## **REGULAR MEETING AGENDA**

**Tuesday, February 25, 2025  
6:30 P.M.**

## **Preliminary Site Plan and Special Use Review For Ypsilanti Township, Michigan**

<b>Applicant:</b>	UPH Ypsilanti Property LLC (Represented by Charles Paisley)
<b>Project Name:</b>	Culver's Restaurant and Drive-Through
<b>Plan Date:</b>	July 18, 2024
<b>Latest Revision:</b>	December 20, 2024
<b>Location:</b>	1410 Huron St. (On west side of South Huron Street, just north of Aldi site at Brinker Way)
<b>Zoning:</b>	FB, Form Based District – Town Center
<b>Action Requested:</b>	Preliminary Site Plan and Special Use Approval

**10 ELEV. DUMPSTER ENCLOSURE**  
C-1 SCALE: 1/4" = 1'-0"

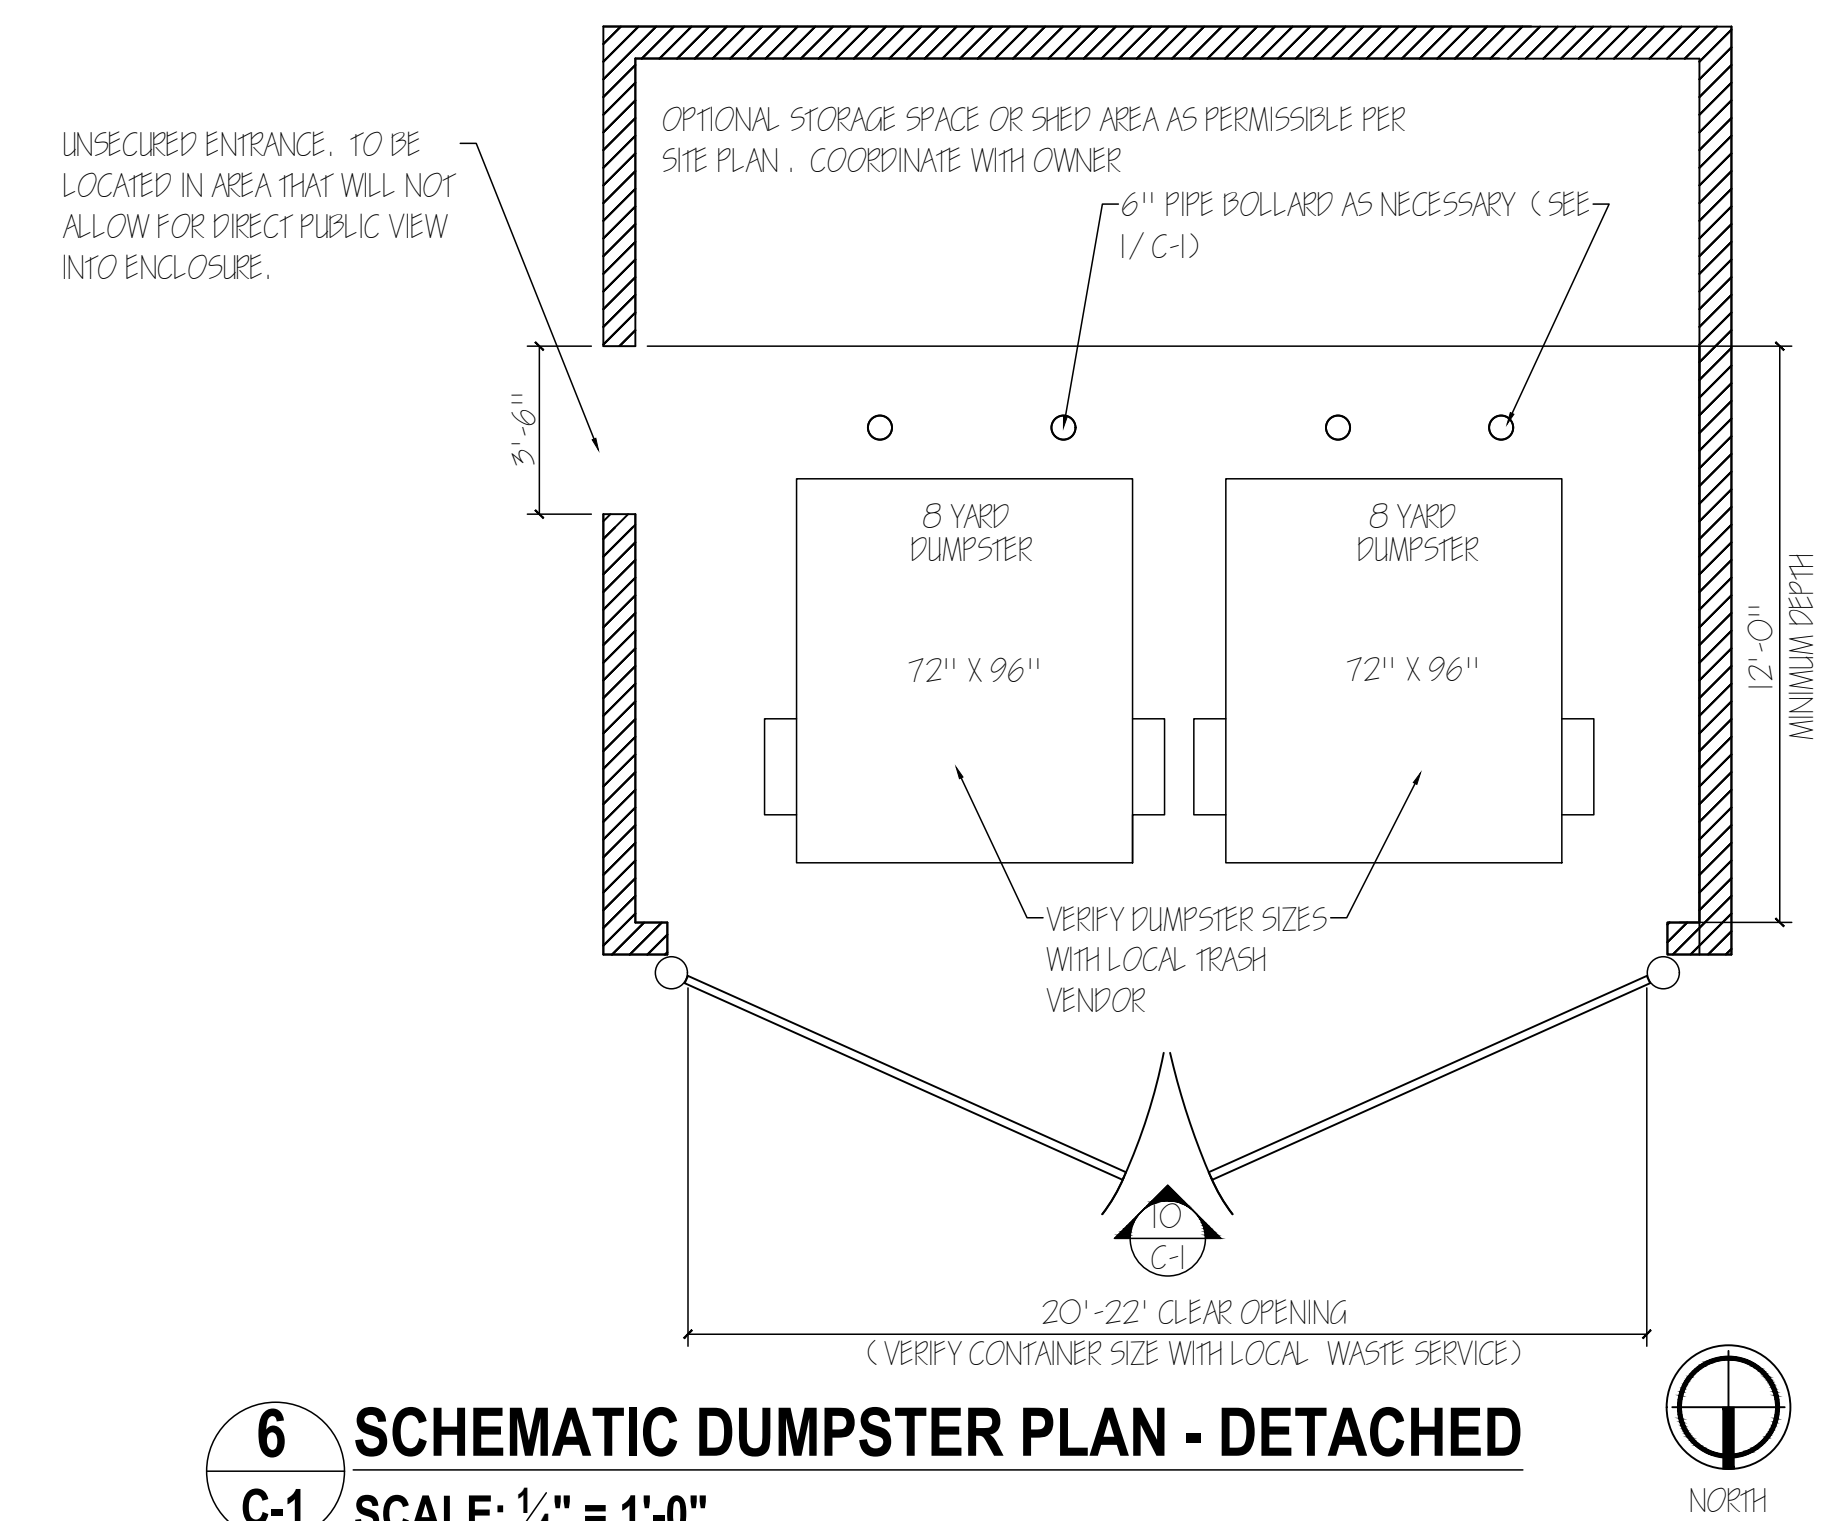
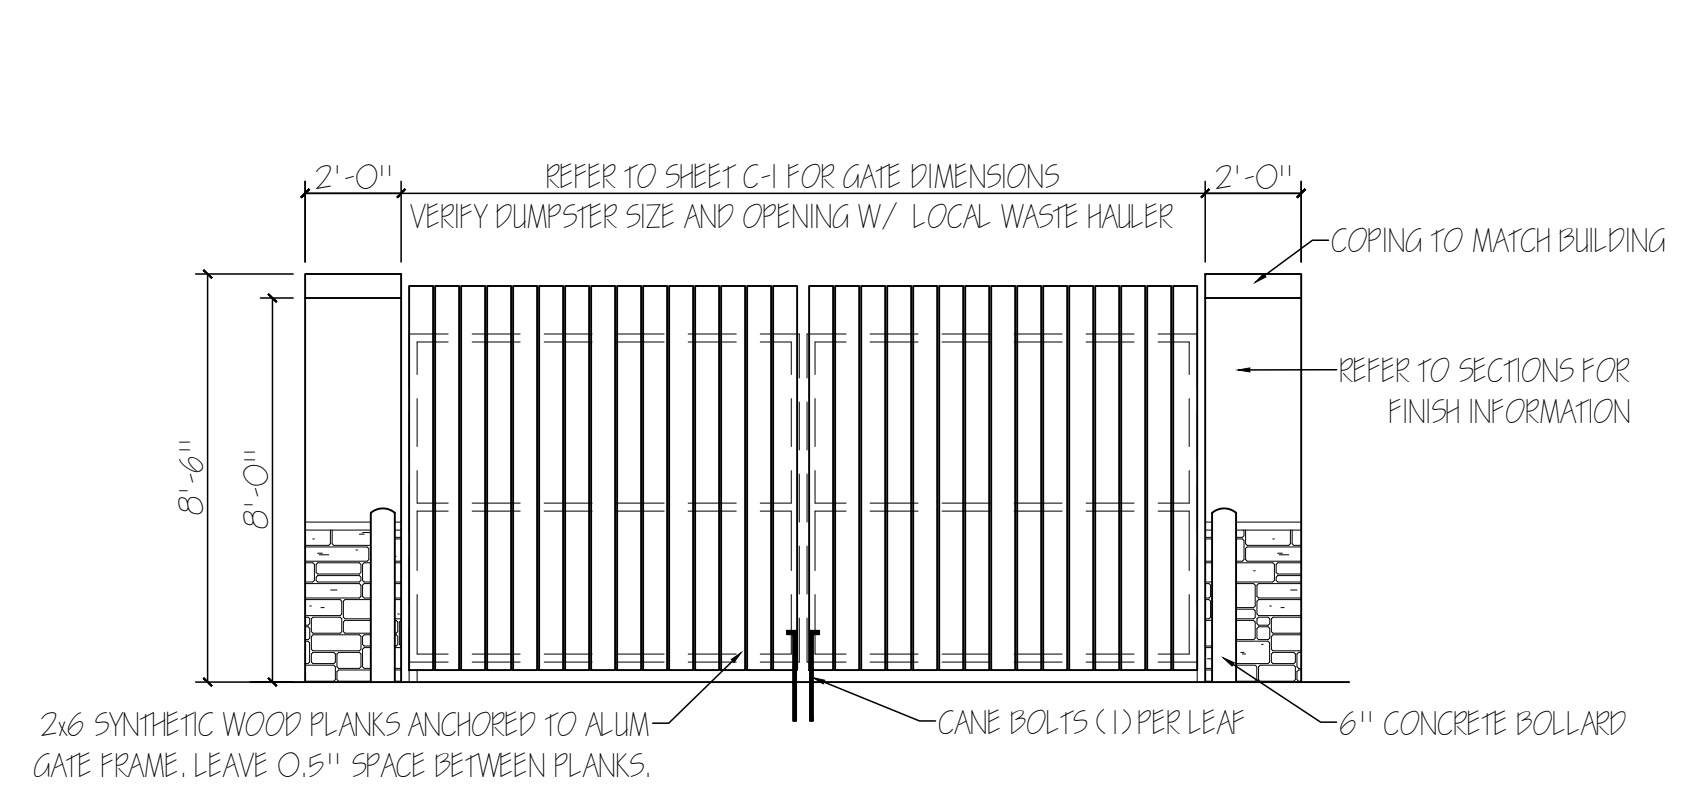
A dumpster screen detail is provided on Sheet C-1, showing an 8-foot-tall dumpster screen. The Form-Based ordinance requires that the screen's materials be consistent with the building walls. The screen details indicate that the veneer on the screen will be manufactured stone to match the building, meeting this requirement.

## SOUTH ELEVATION

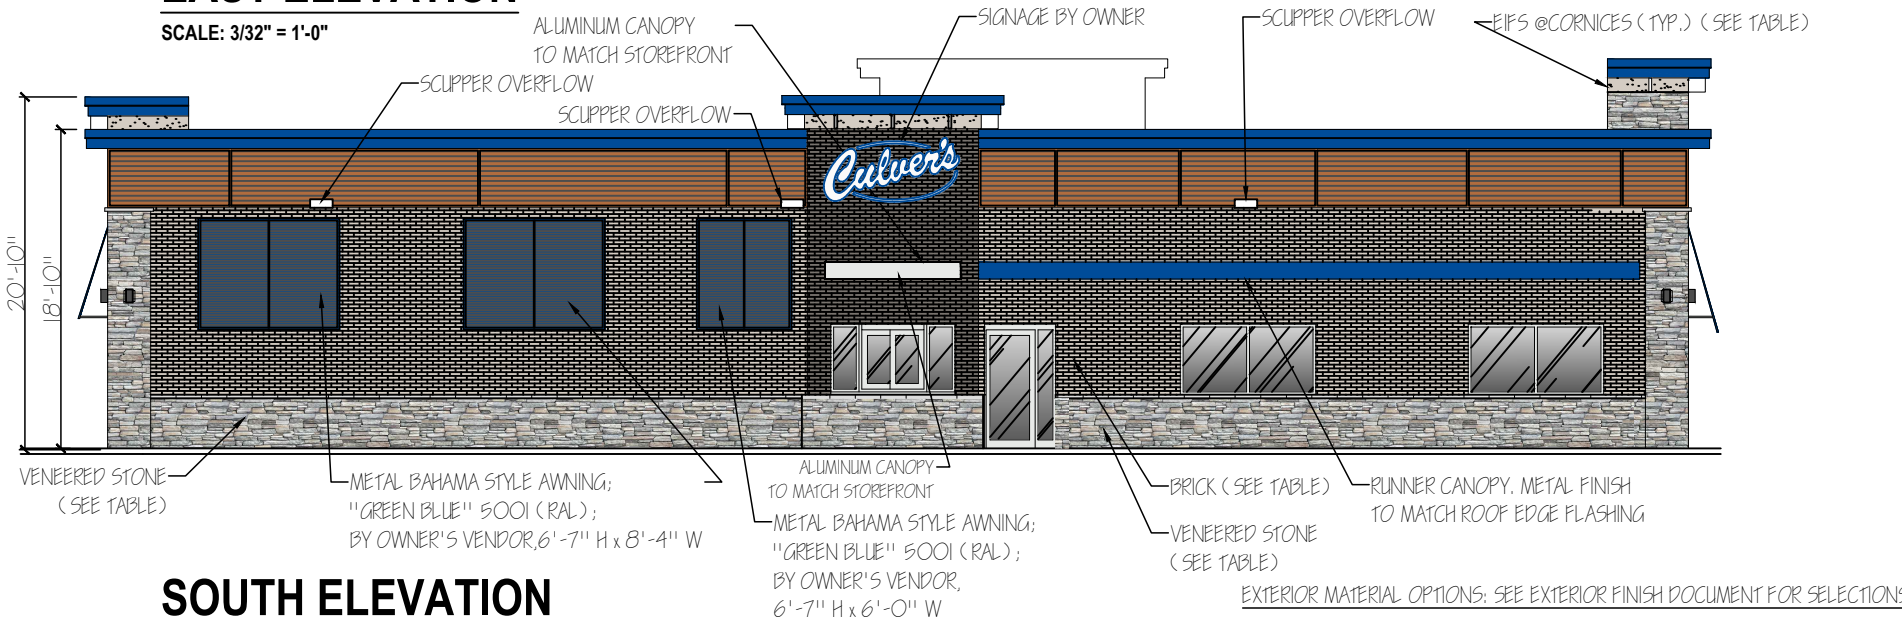
- 1) Confirm proposed awning location on South Elevation.*
- 2) Applicant to modify the front façade to bring up to 50% transparency requirement, or obtain a variance.*
- 3) Planning Commission to consider “transparency alternative” for the parking lot side (north façade), using the patio to count toward the 30% transparency requirement on this facade.*
